# WASTEWATER FACILITES PLAN REPORT

# **Brookfield Water Pollution Control Authority**

August 2020

Response to the Facilities Plan Pump Station's Deficiencies Water Pollution Control Authority Brookfield, CT 06804

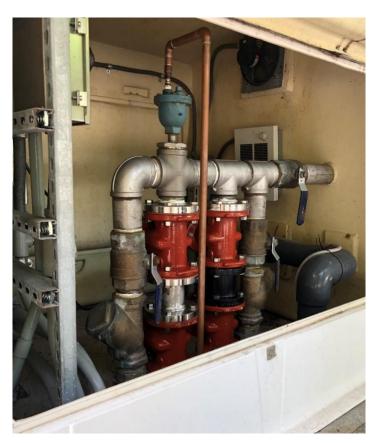
• NFPA 820 required a 5-foot separation between any source of gas and all electrical equipment. The exhaust fan in the fiberglass enclosure and wet well vent are within 5-feet of the electrical equipment enclosure. To address these items, we recommend the existing exhaust fan be replaced with a continuously running supply fan, the air intake damper to be changed to an exhaust air damper and re-route the vent pipe to the opposite side of the fiberglass enclosure.

#### **COMMERCE PUMP STATION**

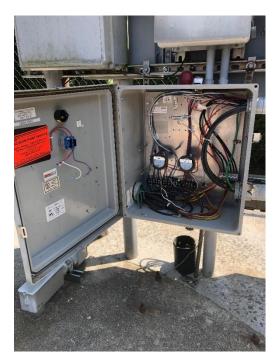
1. Draft Facilities Plan Deficiency comment (page 4-13): The pumping station is not NEC compliant for an explosive area. The electrical and control panels are within three feet of the wet-well hatch opening and vents. The close proximity requires NEMA 7 components.

Langan/Keystone Comments: This is a pump station that was recently taken over by the WPCA and many of these conditions existed when the WPCA took over the operation and maintenance of this system. The wet well hatch as an 18-inch high and 3'-0" wide class 1, division 2 area classification around it. There is one (1) piece of equipment mounted on the rack that measures 15-inches from the ground. We recommend this enclosure be replaced with a smaller box which will then bring the bottom of the equipment to 18-inch from the ground. This equipment box serves as a splice box to the pump control panel and can easily be modified as recommended and the pump run time meter can be relocated into the pump control panel if necessary.

#### Damming and Pouring:

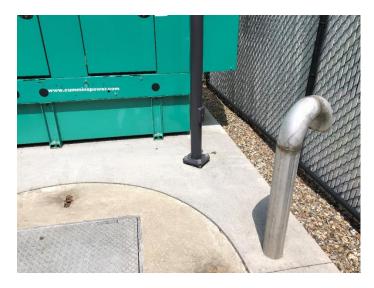
• The vent pipe is located 4'-10" from the generator. It is recommended to rotate the vent pipe to face the opposite direction of the generator to provide a 5'-0" clearance.

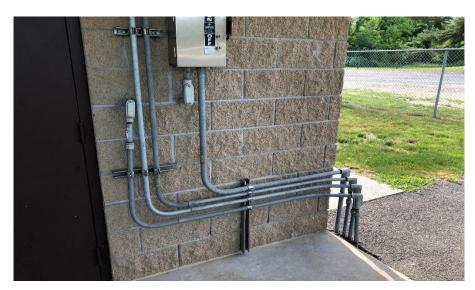
1. Draft Facilities Plan Deficiency comment (page 4-25): Multiple NEC compliancy issues.

- The wet well fan is explosion proof but it is not a supply fan. The exhaust fan has a 5-foot radius which is class 1, division 1 and a 10-foot radius of class 1, division 2 per NFPA 820. This radius extends inside the pump station building through the double doors. We recommend to replace the exhaust fan with a supply fan to force air down into the wet well.
- The vent pipe is 4'-4" from the building and is required to be 5-feet. We recommend that the existing vent pipe be capped and a new vent pipe installed in the new wet well.

**Langan/Keystone Comments:** The draft Facilities Plan does not identify the compliancy issues. Based on our site visit, we have identified specific items that we recommend be placed on the maintenance and/or upgrade program to bring the pump station into compliance with the current NEC and NFPA standards. These items are as follows:

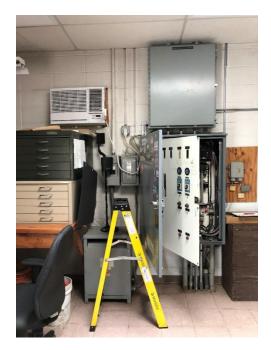
There are exposed wires with broken conduits. This is a NEC code violation per NEC 300.4. We believe these conduits/wires are abandoned and if so, conduit should be removed and the opening sealed watertight material (see photo below for reference).
